Access Compliance Report Public Rights-of-Way (Curb Ramps)

Main Street: HAZARD_AVE Cross Street: N/A Location: NW

ADA ID: RPRK220203122513 Ramp Type: Type 4 - Parallel Initial Pass/Fail: Fail Overall Compliance: No Severity Score: 15

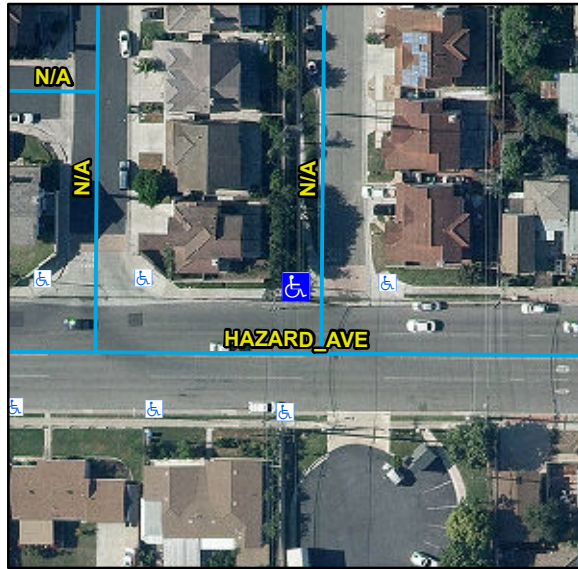
Compliance	Description	Data	Compliance	Description	Data
N/A	Ramp Length LT (in)	108	N/A	Ramp Length RT (in)	116
Yes	Ramp Width LT (in)	60	Yes	Ramp Width RT (in)	60
Yes	Ramp Run Slope LT (%)	3.2	No	Ramp Run Slope RT (%)	8.4
Yes	Ramp Cross Slope LT (%)	1	Yes	Ramp Cross Slope RT (%)	1.9
N/A	Landing Present	N/A	N/A	DWS Provided	N/A
N/A	Landing Length (in)	N/A	N/A	DWS Contrast	N/A
N/A	Landing Width (in)	N/A	N/A	DWS Length (in)	N/A
N/A	Landing Run Slope (%)	N/A	N/A	DWS Full Width	N/A
N/A	Landing Cross Slope (%)	N/A		DWS Offset Type	N/A
N/A	Landing Movement Obstructed?	N/A	N/A	DWS Offset Left (in)	N/A
	Landing Movement Type	N/A	N/A	DWS Offset Right (in)	N/A
N/A	Landing Shared	N/A			
N/A	Clear Space	Yes			
N/A	Clear Space To Crosswalk (in)	N/A			
N/A	Marked Crosswalk 1	No	N/A	Marked Crosswalk 2	No
	Crossing 1 Direction	S		Crossing 2 Direction	E
	Marked Crosswalk 1 Width (in)	N/A		Marked Crosswalk 2 Width (in)	N/A

Remove & Replace Curb Ramp With Two New Directional Ramps or Equivalent.

R304.3.2, STD 1115
